4 WARRINGTON DAM, BUCKS COUNTY
PENNSYLVANIA

5
6 PHASE I INSPECTION REPORT
NATIONAL DAM INSPECTION PROGRAM.

PHASE I INSPECTION REPORT
NATIONAL DAM INSPECTION PROGRAM

Name of Dam:	Warrington Dam
County Located:	Bucks County
State Located:	Pennsylvania
Stream:	Little Neshaminy Creek
Coordinates:	Latitude 40° 13.6'
	Longitude 75° 9.6'
Date of Inspection:	23 April 1979

FIELD OBSERVATION PLAN
WARRINGTON DAM
SHEET 5A OF 11

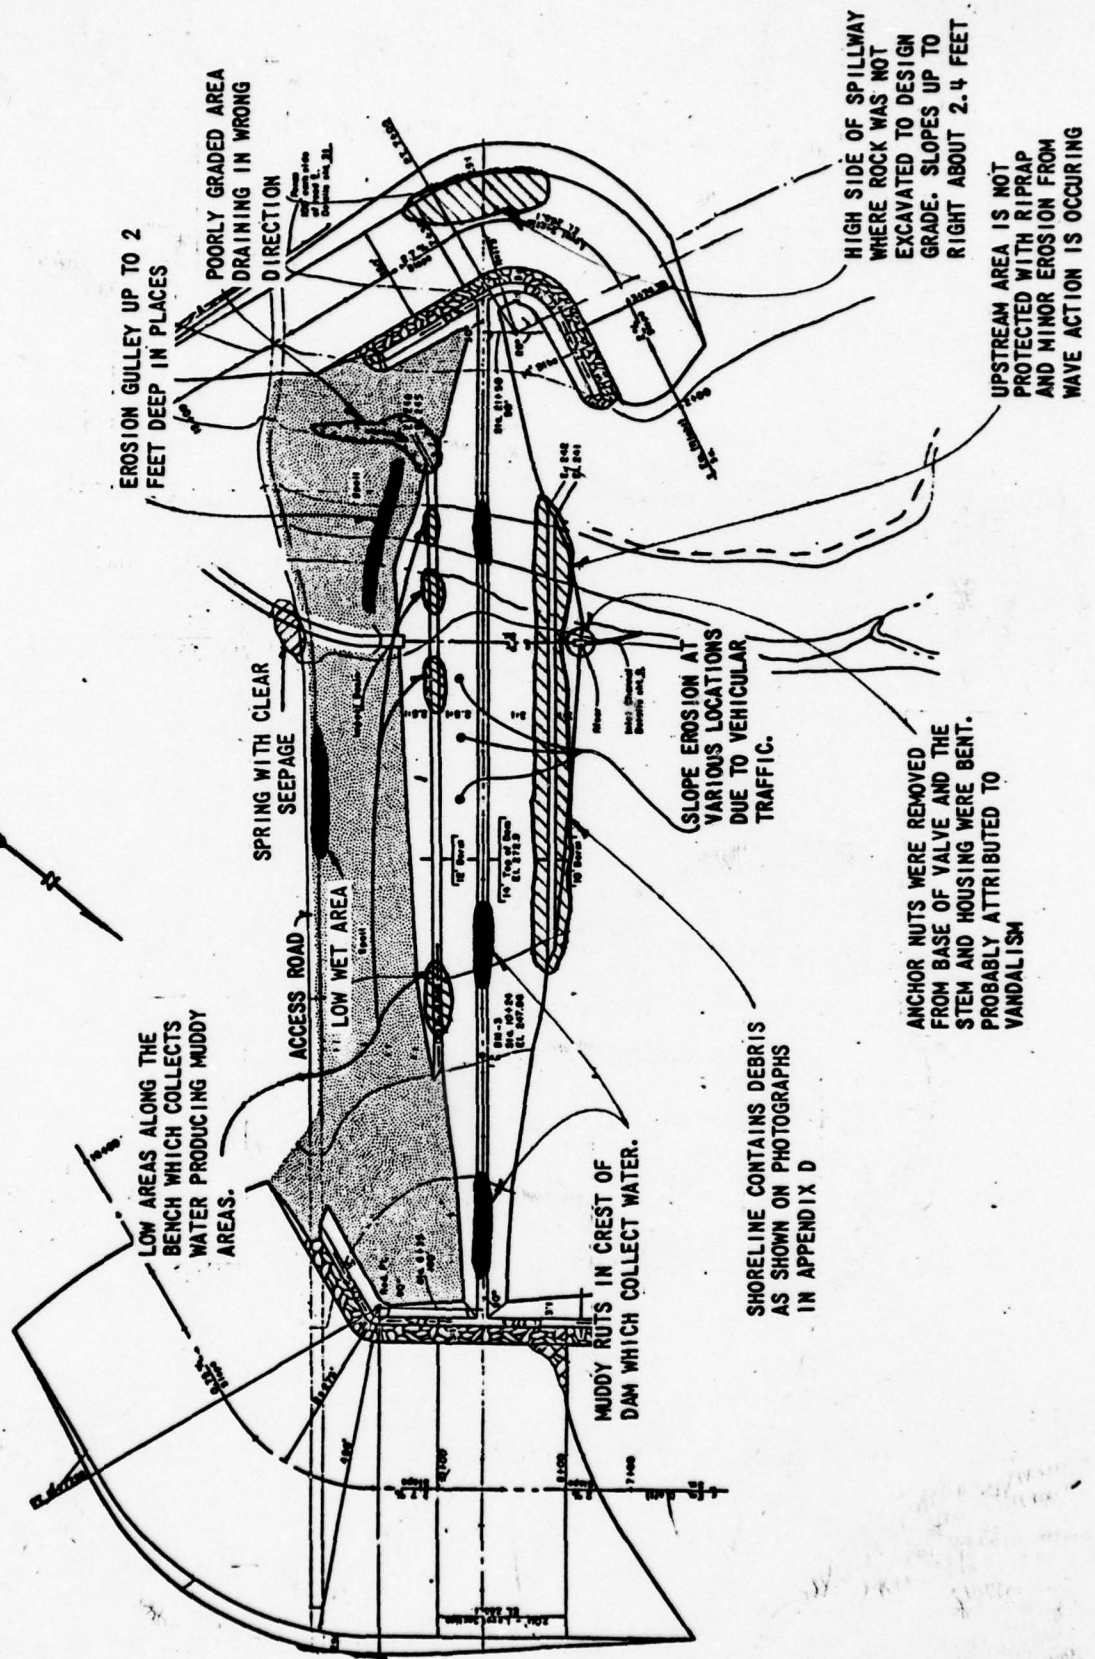
The only seepage noted is shown on sheet 5a and is located downstream of the dam beyond the spoil area along an access road. This seepage was assessed to be associated with a localized rise of groundwater as a result of impoundment behind the dam.

As shown on Sheet 5a the crest contains rutted and muddy areas and the benches contain low points due to poor grading which collects water.

As shown on Sheet 5a, wet areas and a spring were noted 120 to 150 feet downstream of the toe along an access road. These wet areas with clear flowing water are probably associated with the local rise in the groundwater. Very slight seepage upstream of impact basin, no erosion noted.

4. Seepage noted beyond the downstream toe should be monitored. If there is an increase in the seepage, appropriate remedial measures should be taken.
